APPLICATION NO.	FILING DATE	FIRST NAMED INVENTOR	ATTORNEY DOCKET NO.	CONFIRMATION NO.
10/676,767	10/01/2003	Michael Samuel	522.0001	7915
3404	7590	08/09/2005	EXAMINER	
PURDUE LAW OFFICES 2735 N. HOLLAND-SYLVANIA ROAD SUITE B-2 TOLDEO, OH 43615			CHAN, KO HUNG	
			ART UNIT	PAPER NUMBER
			3632

Office Action Summary

10/676,767

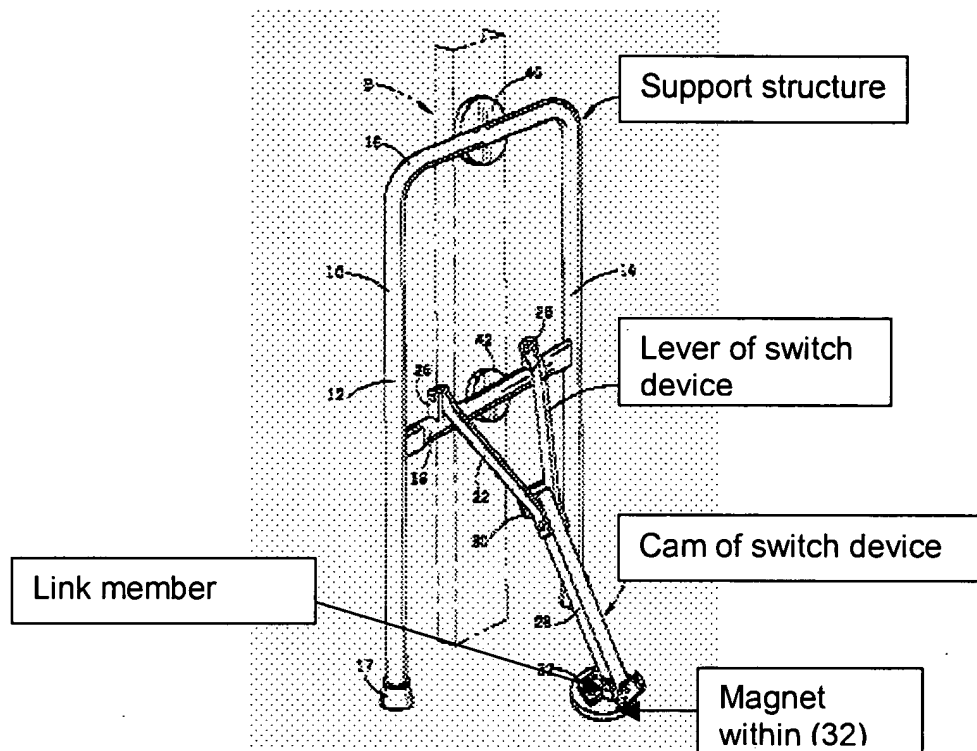
Claims 1-4 and 6-11 are rejected under 35 U.S.C. 102(b) as being anticipated by Schillero, Jr. (US patent no. 6,029,407). Schillero Jr. disclosed all the claimed features of applicant's invention as illustrated below.

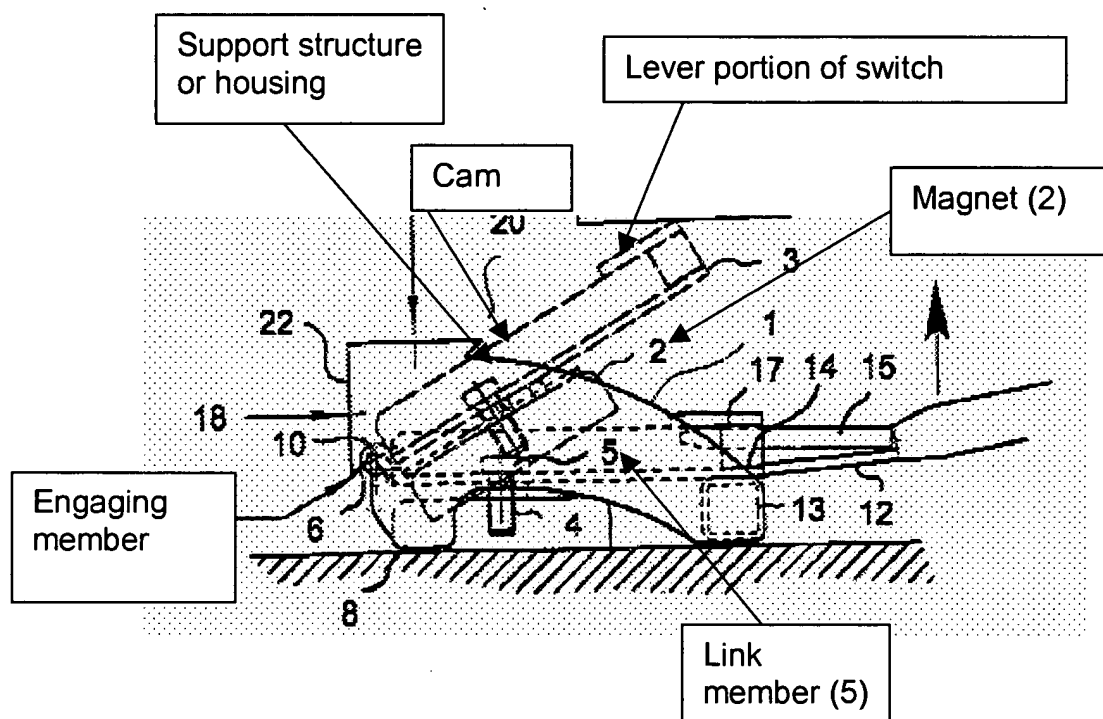
Claims 1-4, 6-8, 10, 15, 16, 22-24, 26-30, 33, and 34 are rejected under 35 U.S.C. 102(e) as being anticipated by Vappula (US patent no. 6,547,209). Vappula disclosed all the claimed features of applicant's invention as illustrated below

Claim 7 has a different interpretation than claims 8-10, where the lever is element (3) being detachably coupled to cam member (5).
